MONTGOMERY COUNTY HISTORIC PRESERVATION COMMISSION
STAFF REPORT

Address:	34 West Kirke St., Chevy Chase	Meeting Date:	11/14/2018
Resource:	Contributing Resource Chevy Chase Village Historic District	Report Date:	11/7/2018
Applicant:	Thomas Dann (Derek Binsted, Architect)	Public Notice:	10/31/2018
Review:	HAWP	Tax Credit:	Partial
Case Number:	35/13-18HH	Staff:	Michael Kyne
PROPOSAL:	New dormers and skylights

Fig. 1: Subject property.

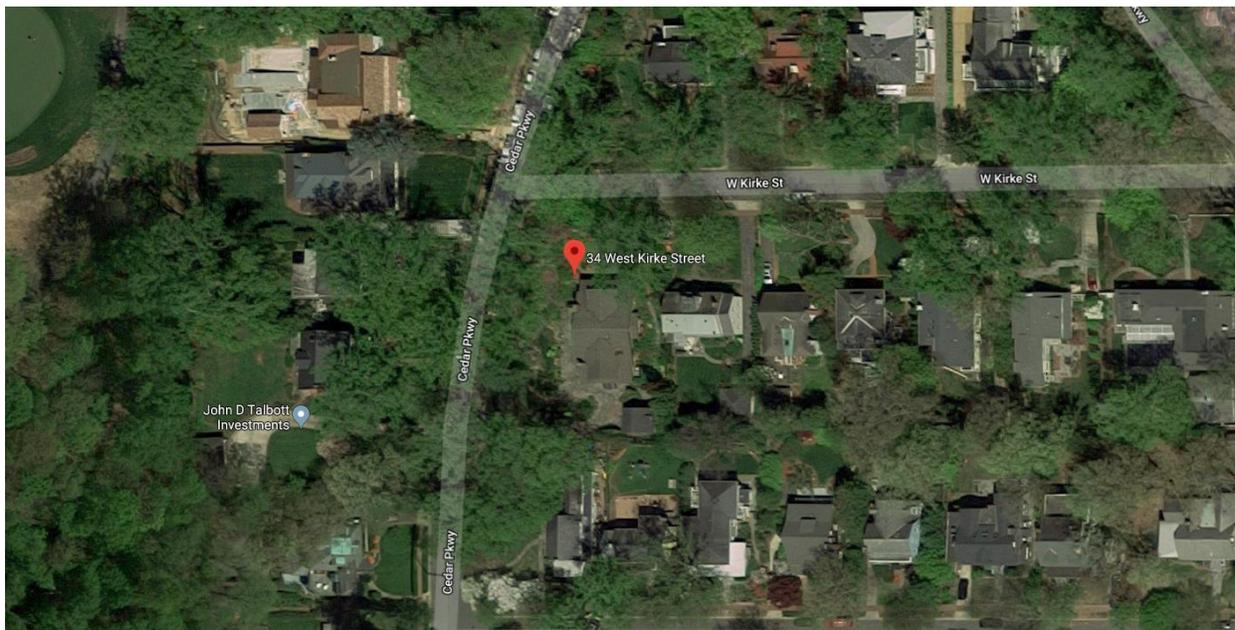
The subject property is a c. 1892-1916 bungalow-style Contributing Resource within the Chevy Chase Village Historic District. The property is on a corner lot, with its driveway and garage accessed via Cedar Parkway. The property has experienced some renovations over the years, including a rear addition, which was approved by the HPC in 2016.

The applicant proposes to install two new shed dormers at the rear of the house, with one on each side of the existing centered gable dormer. The materials of the proposed dormer will match the existing, with cedar shingle siding, cedar shake roofing, and 4-lite SDL wooden casement windows. The windows will have 5/8" putty profile muntins, which will permanently-affixed on the interior and exterior, and spacer bars. A 2' x 2' skylight will be installed on the roof of the westmost dormer (Cedar Parkway side).

Staff supports the applicant's proposal, finding that the proposed alterations will not remove character-defining features of the subject property or detract from the surrounding streetscape, in accordance with the *Guidelines* and *Standards*.

Staff recommends that the Commission **approve** the HAWP application under the Criteria for Issuance in Chapter 24A-8(b), having found that the proposal is consistent with the *Chevy Chase Village Historic District Guidelines* identified above, and therefore will not substantially alter the exterior features of the historic resource and is compatible in character with the district and the purposes of Chapter 24A;
